Whitehouse Planning Commission Meeting Notice

DEVELOPMENT PLAN OF *Whitehouse Square Townhomes*

**STAFF REPORT
PLANNING COMMISSION
Site Plan Review 08-2018
Whitehouse Square Townhomes
January 7, 2019**

Request: Preliminary approval of Whitehouse Square Townhomes consisting of 132 residential units on individual lots in the Whitehouse Square TND.

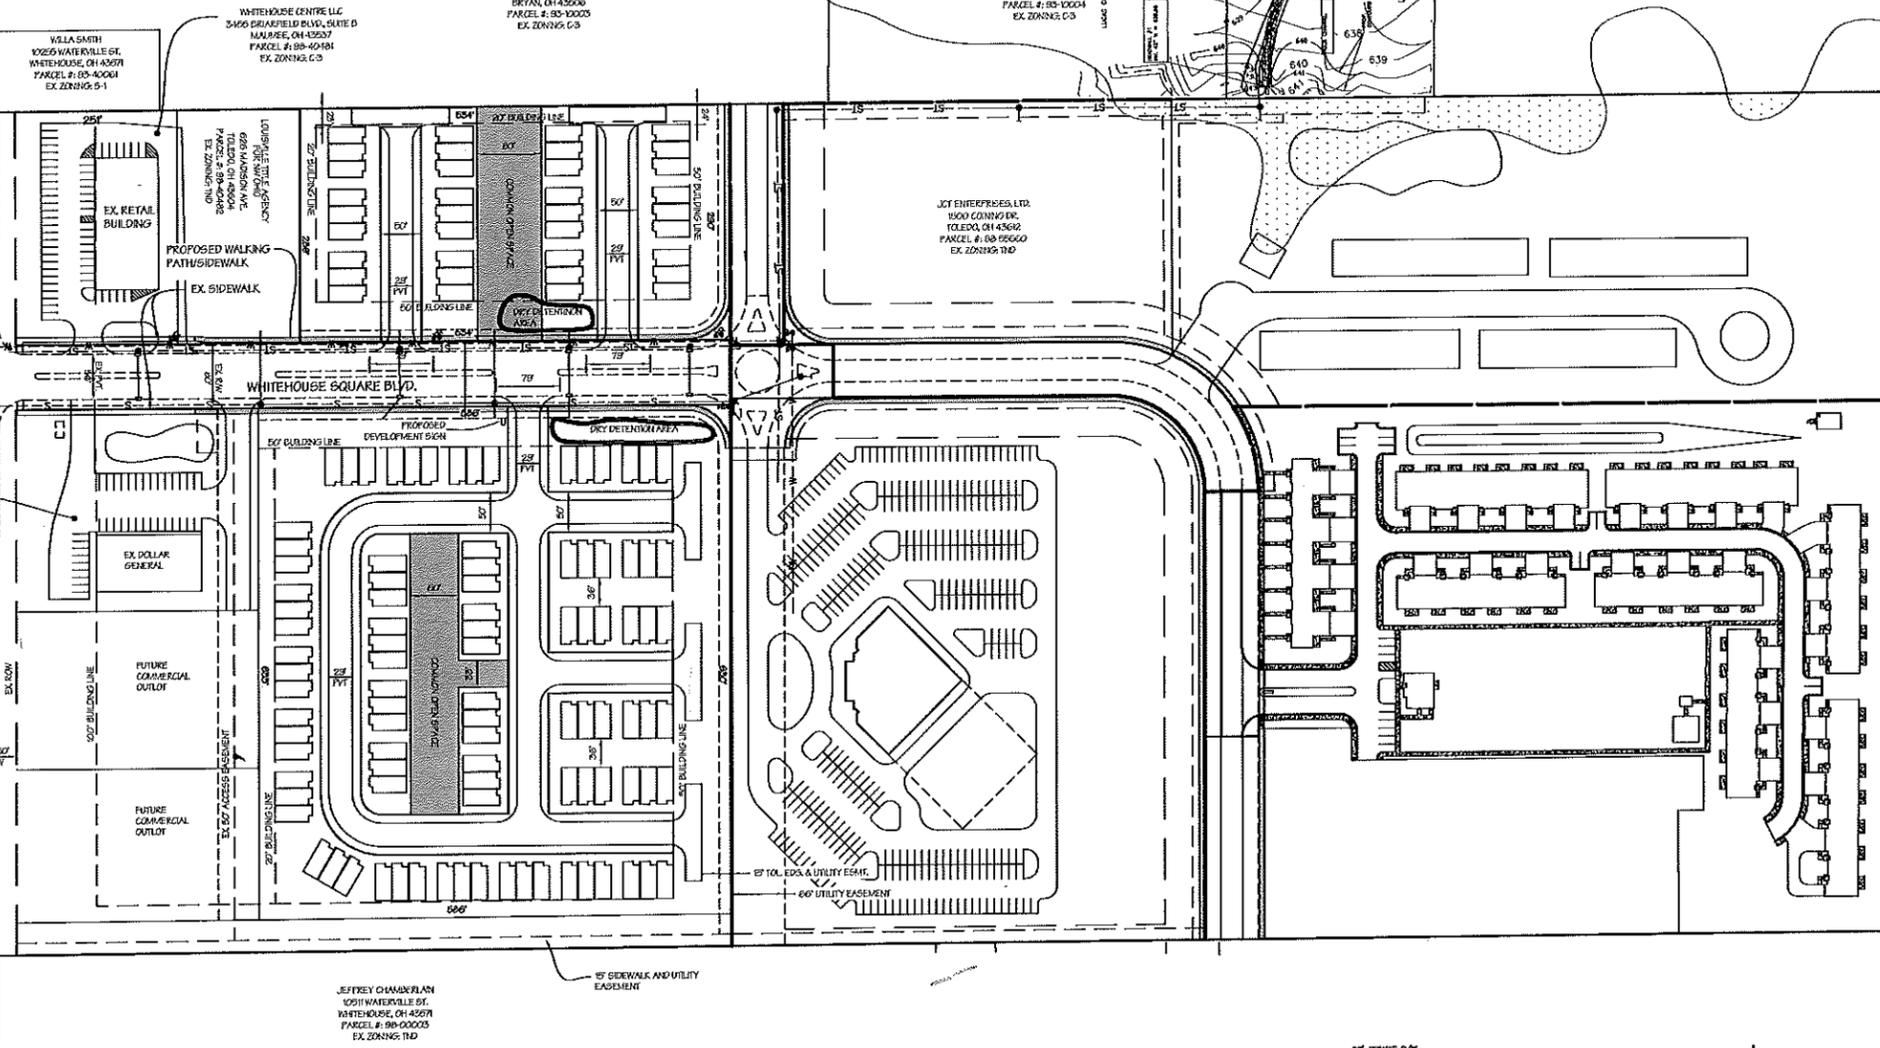
3. Both areas are shown to have access from Whitehouse Square Boulevard, with ingress and egress onto proposed private streets, shown as fifty (50) feet right-of-way with twenty-nine (29) feet of pavement. Will the internal private streets be built to Village standards with curb and gutters? Will sidewalks be required along the private streets? Will parking be allowed on the private streets – if so, will emergency equipment be able to travel on the streets when needed? If parking is not allowed, who will patrol and enforce it?

4. The Traditional Neighborhood Development Concept (Exhibit A) allows for a maximum ten (10) minute walk from one boundary to another or any internal destination. Connecting sidewalks leading to and from these areas are not shown. In other words, one has to leave the development from the street access.

5. The plans show a “Proposed walking path/sidewalk” along both sides of Whitehouse Square Boulevard. Currently there is a sidewalk along portions of the Boulevard. Will a concrete sidewalk be required as opposed to a walking path?

8. Should the developer be required to extend both stub streets that are adjacent to these properties? One heads east just to the south of this property at the small roundabout and one heads west behind Dollar General property. In the past developers were required to extend roadways that abut the proposed development.

As stated in this Section, narrow lots require that the parking be accessed from the rear by alleys or lanes. All but fifteen (15) units show front load garages. The remaining 117 residential units show front driveway/garage access off of the unnamed streets. Therefore, a variance of Section 1252.03 to allow garage access from the front of those units will be required.

This site plan shows proposed walking paths/sidewalks along both sides of Whitehouse Square Boulevard. It does not provide for any internal sidewalks or connectivity to other areas in the TND.

The site plan does not show any lampposts along the unnamed streets. The Village will require lights spaced no more than 75' apart, with light fixtures to match what has been installed in the other developments.

The site plan shows a "proposed development sign" at the entrance on the west side of Whitehouse Square Boulevard. Like materials should be used to match what the Village is requiring on the State Route 64 Corridor. Chapter 1259 of the Zoning Code deals with the size and location of signs and must be adhered to before any signage can be approved for this development.

Alleys. This subsection states that "All lots less than fifty (50) feet in width and that front a street or a square shall provide rear alley access for off-street parking. Direct vehicular access from a single lot to a street is not encouraged". A variance must be granted to allow access from the street to each individual driveway and garage.

Sidewalks. The drawing shows proposed walking paths/sidewalks on both sides of Whitehouse Square Boulevard, which meet the requirements of this section. It should be noted that ADA ramps are required at intersections and other major points of pedestrian flow, including where the unnamed streets intersect with Whitehouse Square Boulevard. Construction requirements must meet ORC 729.12 (ramped curbing for handicapped). No sidewalks or paths are shown within the development.

The development to the west is a total of 8.5 acres, which would require 2.5 acres of open space. The plan does not indicate the total area dedicated to open space. Will these common open spaces be considered private for resident use only, or are they open to the public?

3. The Village will require that both unnamed stub streets be extended to the entire length of the property shown on the Development Plan.

4. Streets shall be looped within the development without the use of the permanent hammerhead turnarounds. The development to the west should provide an additional means of ingress and egress, perhaps from the unnamed street running behind Dollar General. This would alleviate some traffic from the one entrance off of Whitehouse Square Boulevard.

Water: The entire water distribution system in the subdivision shall be looped to eliminate the dead ends shown on the plans.

Sanitary Sewer: All sanitary sewers should be constructed in the road right-of-way to avoid special easement areas as shown on the plans.
Currently only 6 inch taps are available on Parcel 98-40476.
